**Additional Response to EPA questions on GHG PSD application - Lone Star,  
Mont Belvieu - Frac II**

**Energy Transfer Partners, L.P. dba Lone Star NGL, LLC**  
**Greenhouse Gas PSD Permit Application**  
**ADDENDUM 1**

Energy Transfer Partners, L.P. dba Lone Star NGL, LLC  
Greenhouse Gas PSD Permit Application  
Response to EPA's Questions dated March 29, April 3, and April 4, 2012

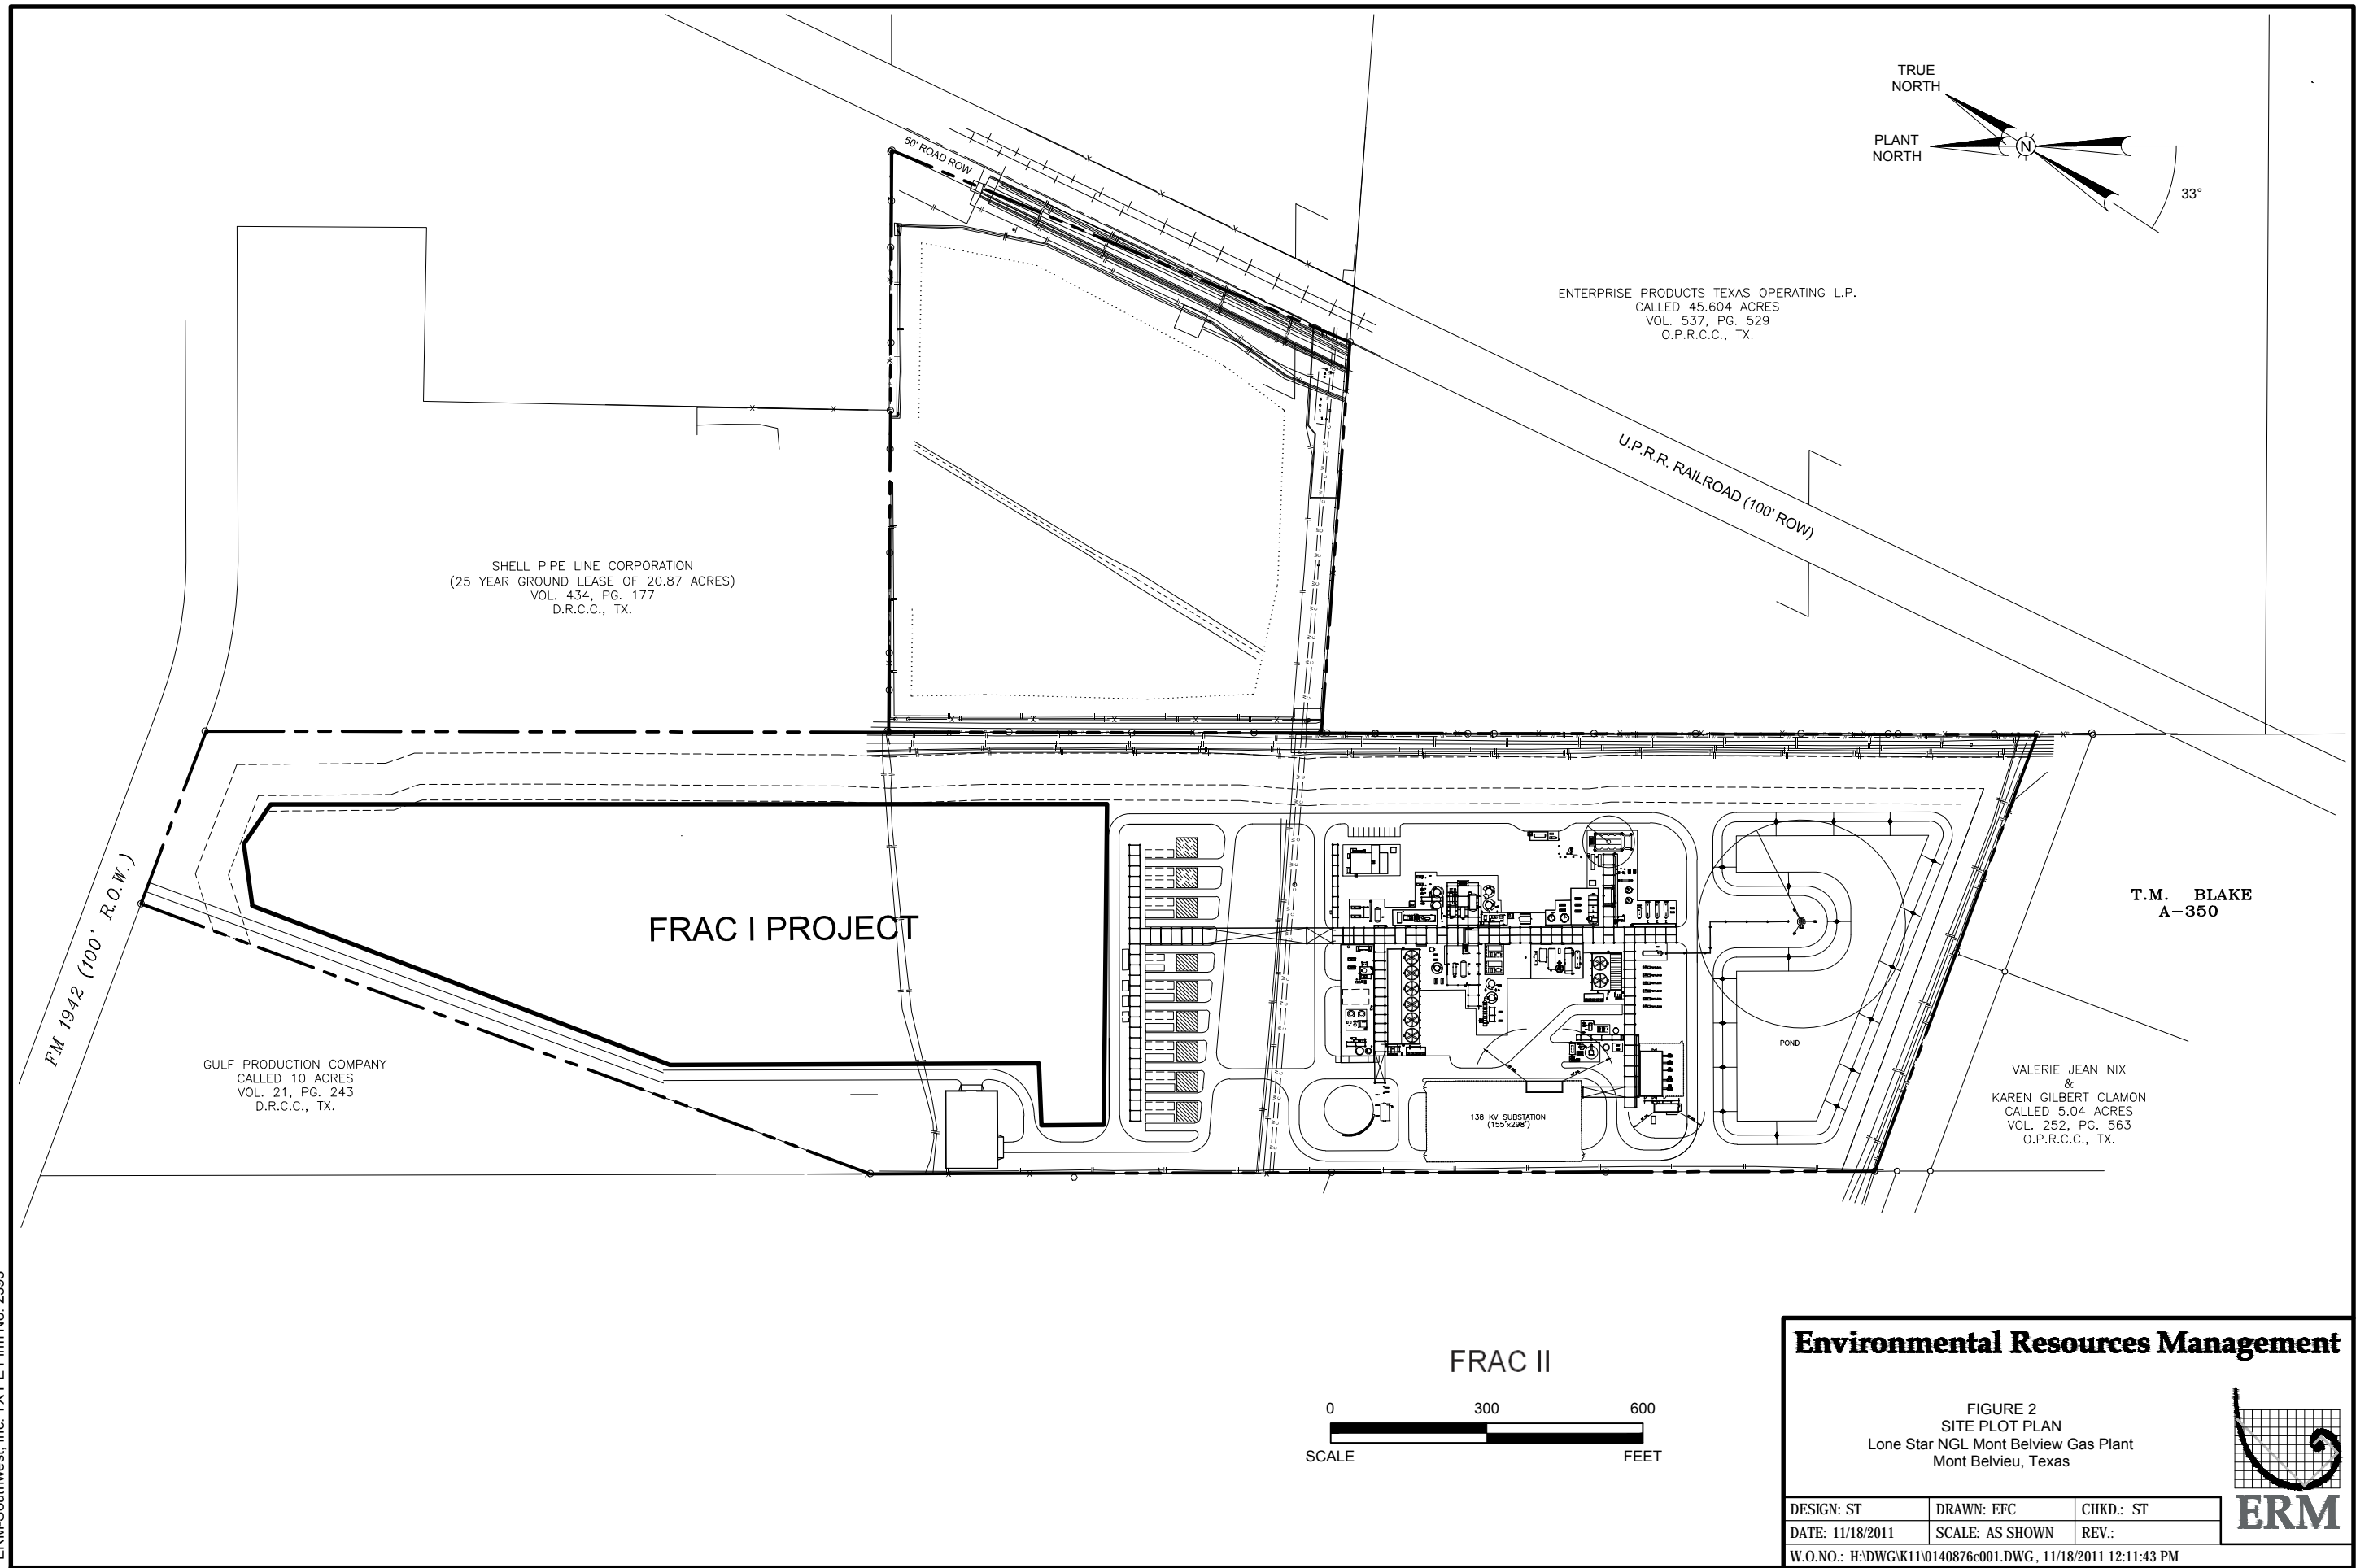
4. *Plot Plan - Can I get a plot plan that identifies the FRAC II project?*

The plot plan submitted with the PSD application shows the proposed FRAC II train. We have labeled the plot plan with the words "FRAC II" to be clear that the plot plan represents FRAC II.
